Site Specific Management Plan 002- [sector 330-340-350]
MacKays to Peka Peka Expressway

17 DECEMBER 2014 - REV C - CERTIFIED ISSUE

SITE SPECIFIC MANAGEMENT PLAN - RAUMATI NORTH [SSMP 2 - SECTOR 330, 340, 350]

Title: LEINSTER AVE TO RAUMATI RD
PLANTING PLAN
SHEET 4

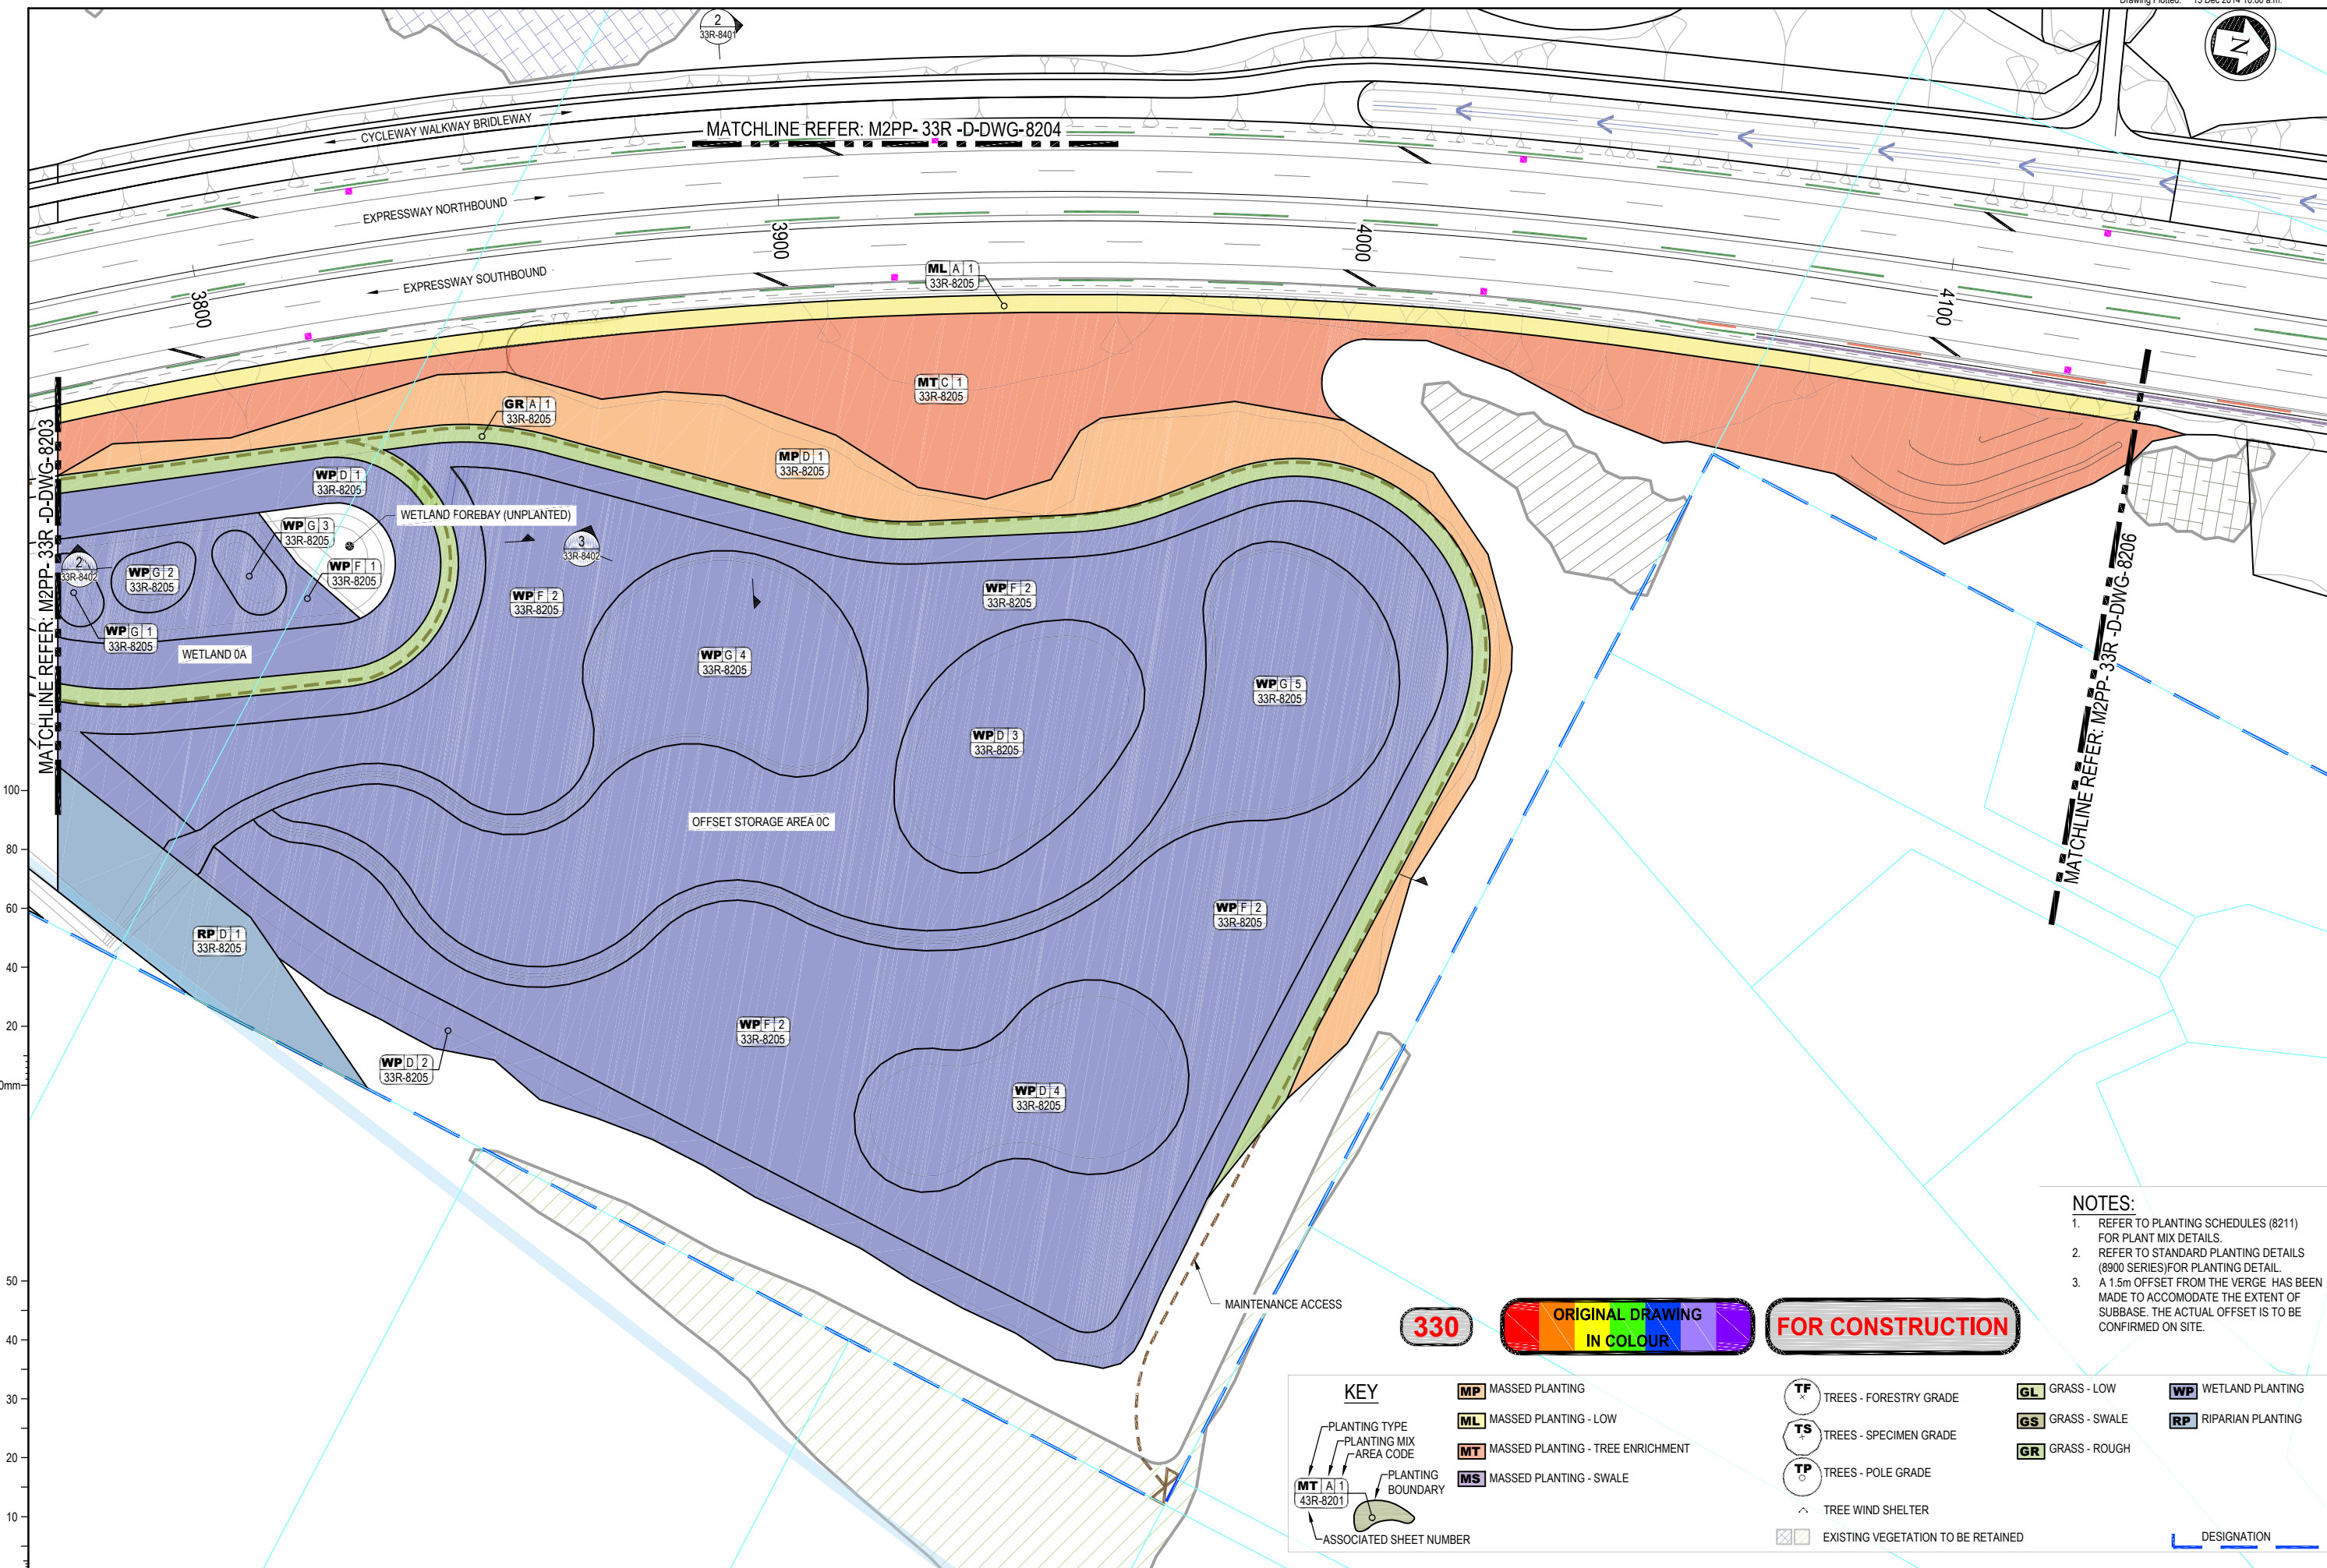
Appendix 1 – Poplar Ave to Raumati Rd Planting Plan Sheet 4	Ecological mitigation planting on engineered batter slope	Does the comment here mean ecological mitigation planting (to mitigate loss of Raumati Kanuka) on batter slope? Or is this area not part of the terrestrial revegetation mitigation treatment? If being counted as terrestrial ecology mitigation, was this ecological mitigation always intended to occur on engineered soils?		The use of kanuka in this general area is to mitigate loss of the Raumati Kanuka and extend the local vegetation character. The focus of mitigation planting is around Raumati Road (sheet 6) but the vegetation type is extended further south to integrate this with the other vegetation; so it is a landscape response that is tied into the mitigation requirement. Yes; this terrestrial mitigation was always intended. No; the batter slopes will not be formed of engineered soils, but of consolidated sands. There is no practical reason that kanuka would not survive and thrive on these batter slopes any differently than they would on a consolidated dune face.

AEE PLAN- RAUMATI ROAD BRIDGE - 1:500@A3

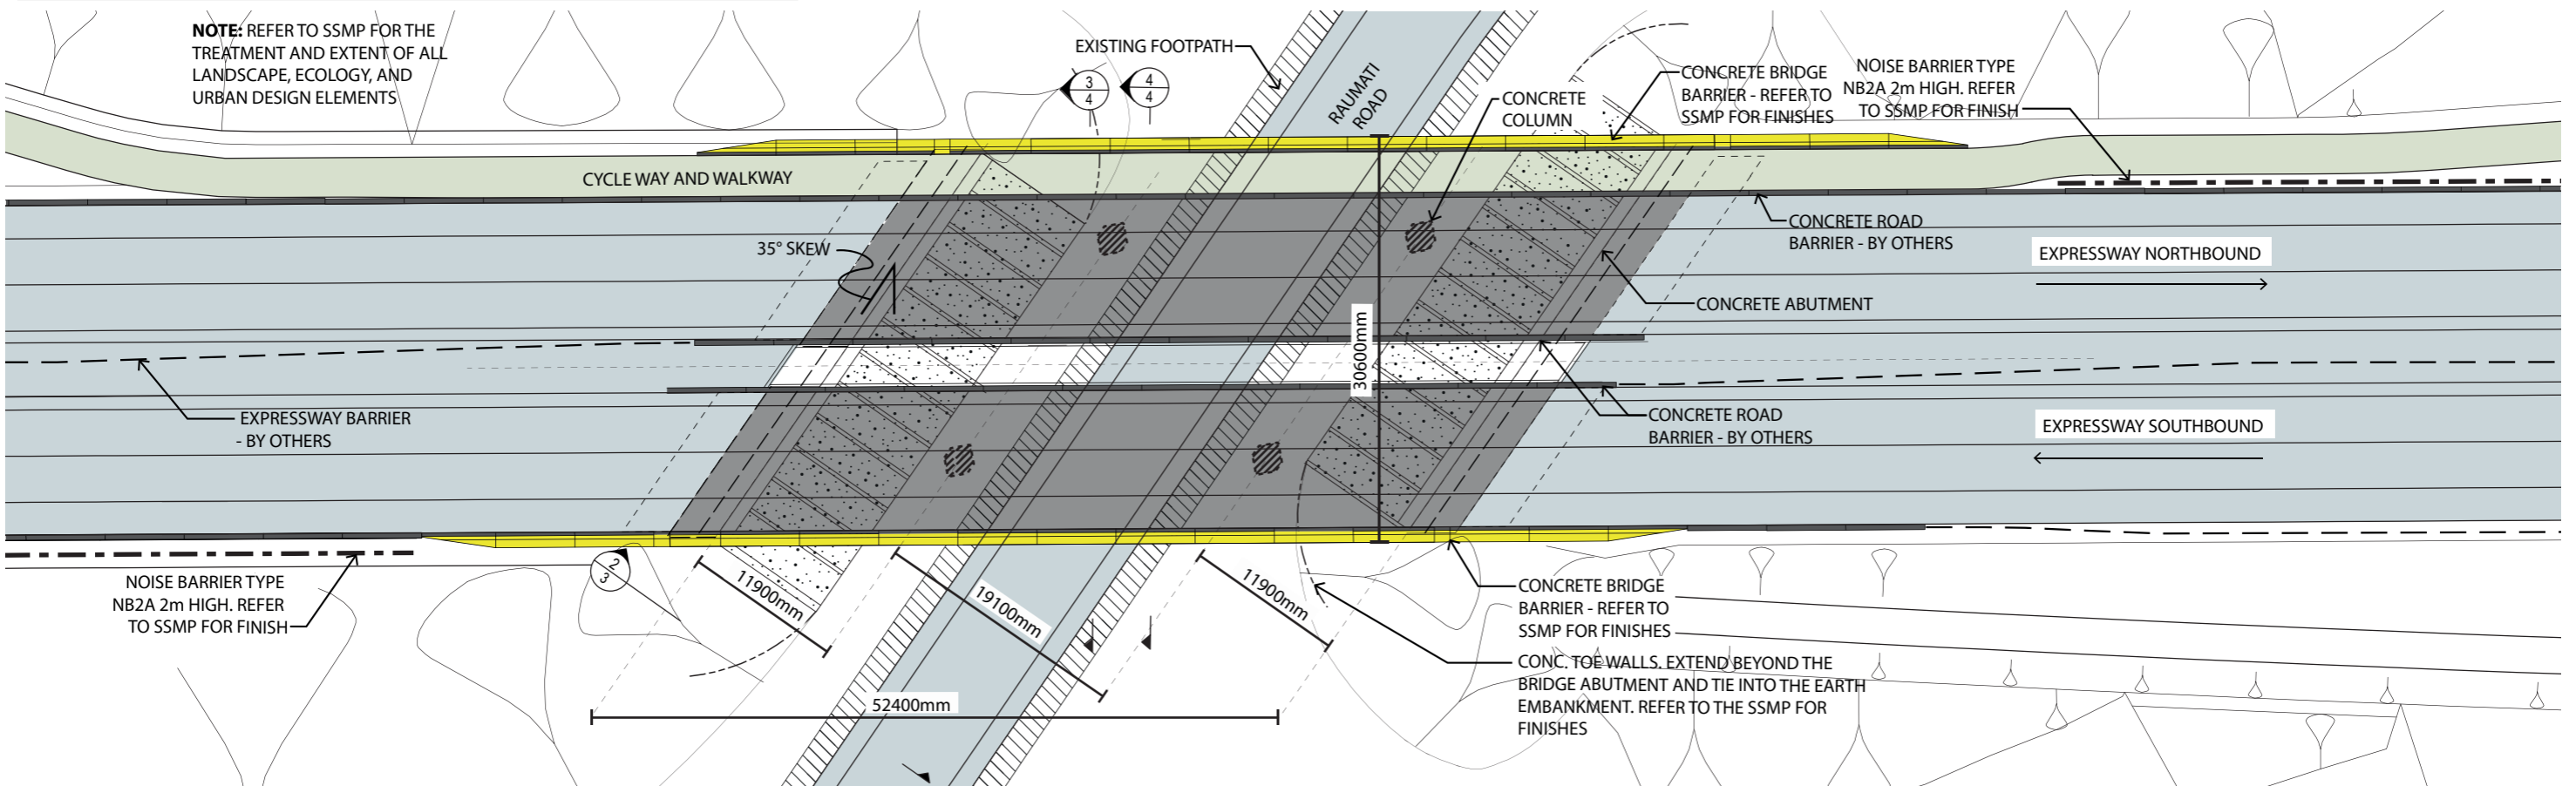
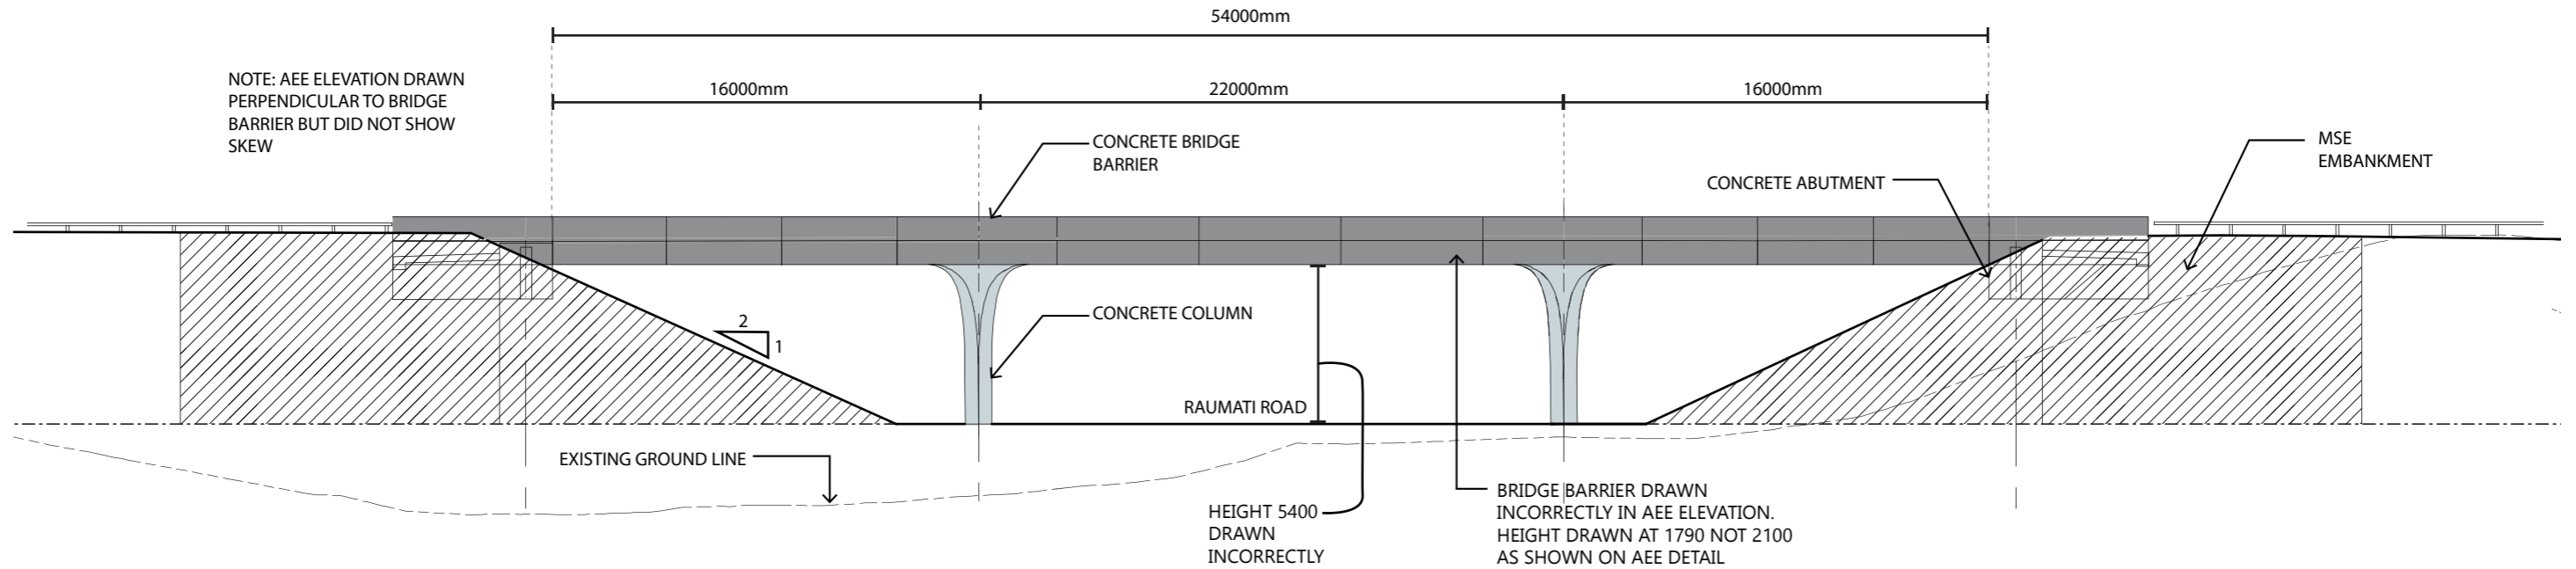
1. Further detail provided for abutment treatment.
2. Column shape and location changed.
3. Local road drawn correctly.
4. Reduced overall length of the bridge.

1. AEE ELEVATION - RAUMATI ROAD BRIDGE EAST ELEVATION - 1:250@A3

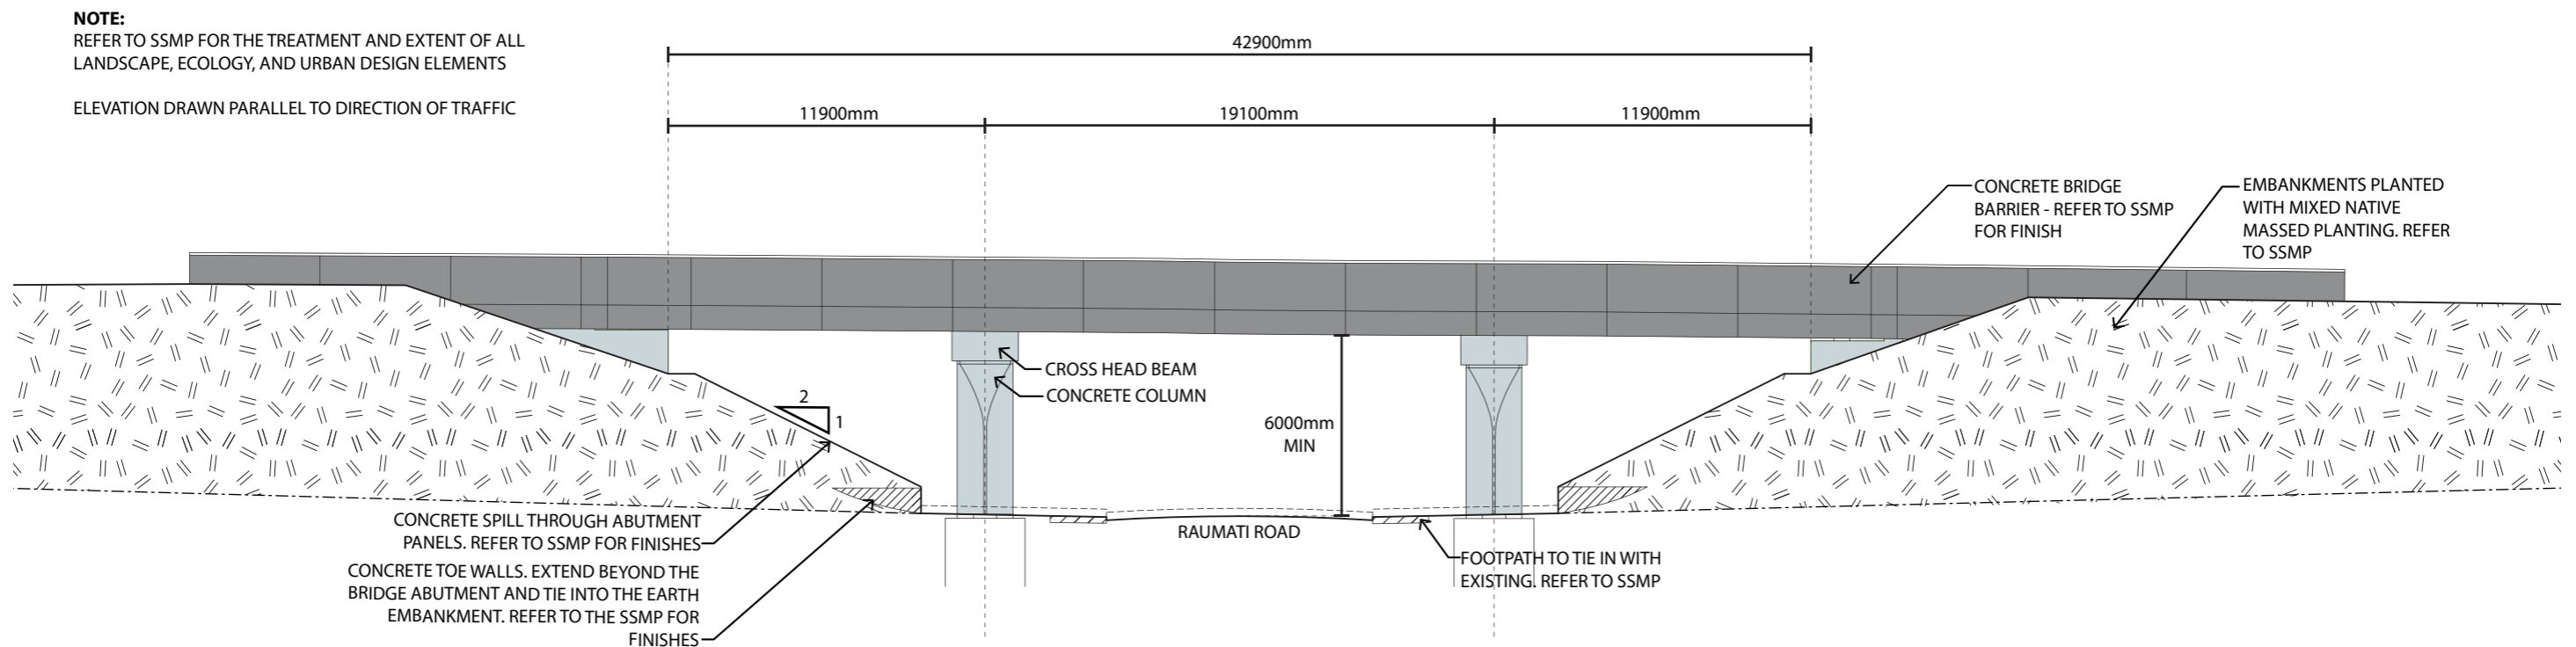
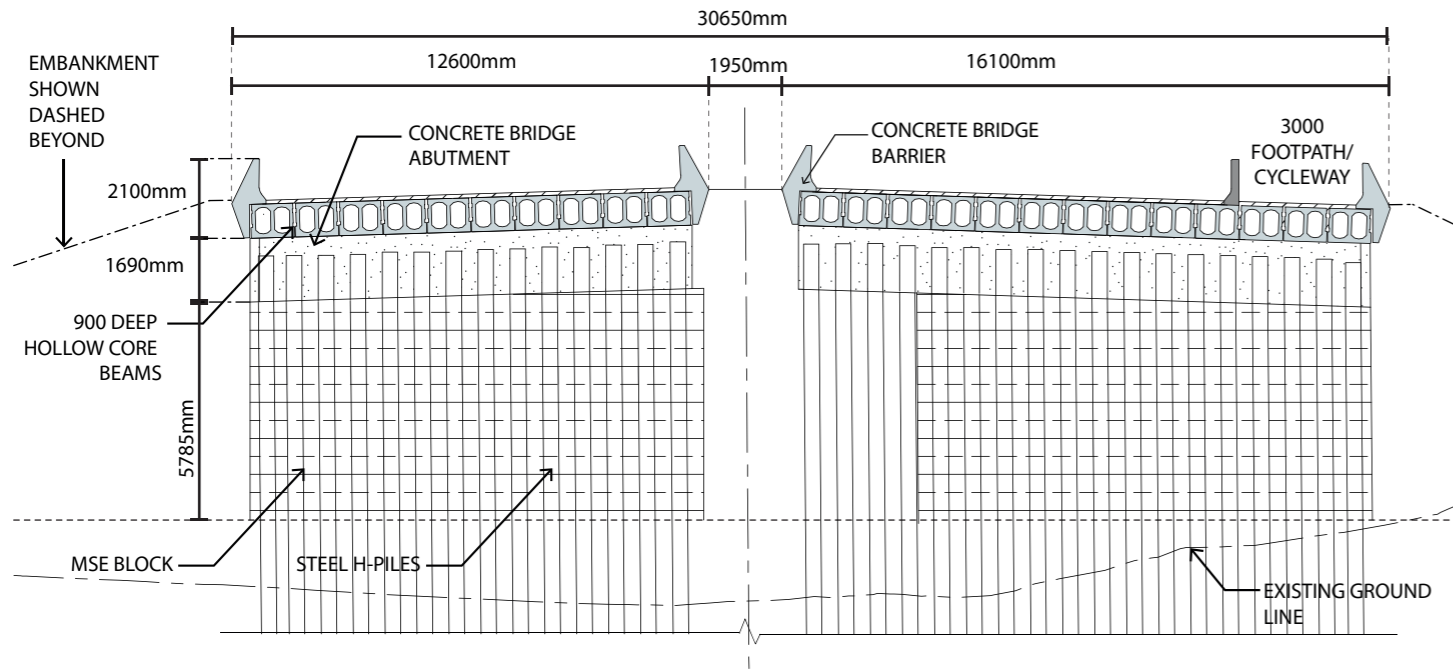
1. Barrier drawn incorrectly in AEE elevation. Change to beam size and type to suit structural requirements of the high skew
2. The AEE elevation was drawn incorrectly. It was drawn perpendicular to the barrier but did not show the skew of the columns. Change from Hollow Core to Super T beams
3. Due to the angle that each elevation has been drawn and the skew of the bridge the abutment will appear steeper no change proposed.
4. Increased structural core based on geotech investigations carried out post AEE, while still providing the sculptural outer.
